Access Compliance Report Public Rights-of-Way (Curb Ramps)

Main Street: WHISPER_CIR Cross Street: DAWNWOOD Location: S

ADA ID: RPRK211025114914 Ramp Type: Type 4 - Parallel Initial Pass/Fail: Fail Overall Compliance: No Severity Score: 2

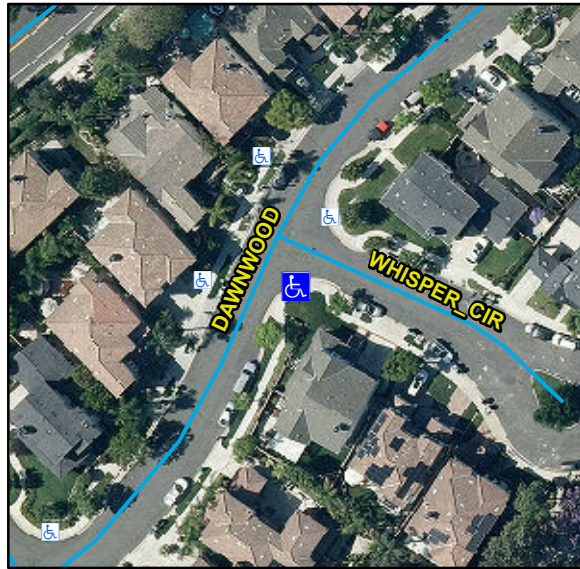
Compliance	Description	Data	Compliance	Description	Data
N/A	Ramp Length LT (in)	111	N/A	Ramp Length RT (in)	113
Yes	Ramp Width LT (in)	53	Yes	Ramp Width RT (in)	53
Yes	Ramp Run Slope LT (%)	6.2	Yes	Ramp Run Slope RT (%)	4.6
No	Ramp Cross Slope LT (%)	3.4	No	Ramp Cross Slope RT (%)	2.9
N/A	Landing Present	N/A	N/A	DWS Provided	N/A
N/A	Landing Length (in)	N/A	N/A	DWS Contrast	N/A
N/A	Landing Width (in)	N/A	N/A	DWS Length (in)	N/A
N/A	Landing Run Slope (%)	N/A	N/A	DWS Full Width	N/A
N/A	Landing Cross Slope (%)	N/A		DWS Offset Type	N/A
N/A	Landing Movement Obstructed?	N/A	N/A	DWS Offset Left (in)	N/A
	Landing Movement Type	N/A	N/A	DWS Offset Right (in)	N/A
N/A	Landing Shared	N/A			
N/A	Clear Space	Yes			
N/A	Clear Space To Crosswalk (in)	N/A			
N/A	Marked Crosswalk 1	No	N/A	Marked Crosswalk 2	No
	Crossing 1 Direction	NE		Crossing 2 Direction	NW
	Marked Crosswalk 1 Width (in)	N/A		Marked Crosswalk 2 Width (in)	N/A

Remove & Replace Curb Ramp With Two New Directional Ramps or Equivalent.
